Automotive and Discrete Group (ADG)
Power Transistor MACRO-Division
HV Business Unit

CUSTOMER NOTIFICATION

Orientation of PowerFLAT™ 8X8 HV Package in carrier tape

INVOLVED PRODUCT: **All products**

NEW PowerFLAT™ 8X8 HV top left Package orientation in carrier tape

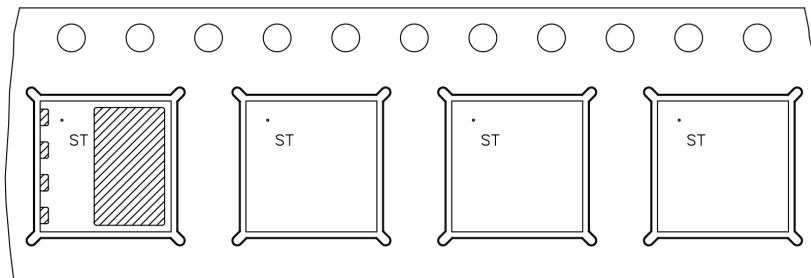
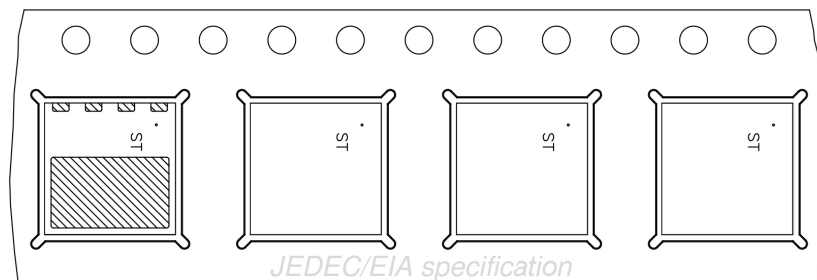
*Purpose of the current notification, is to inform you that despite what is stated in the **PCI ADG/20/12232**, published on June 26, 2020, we are going to restore the PowerFLAT™ 8x8 HV package orientation in carrier tape **to TOP LEFT**. The change will also be reported in the relative datasheets.*

We have gathered negative feedback from our customers and found that very few vendors follow the JEDEC / EIA specification, then the top right orientation creates a continuous equipment setup.
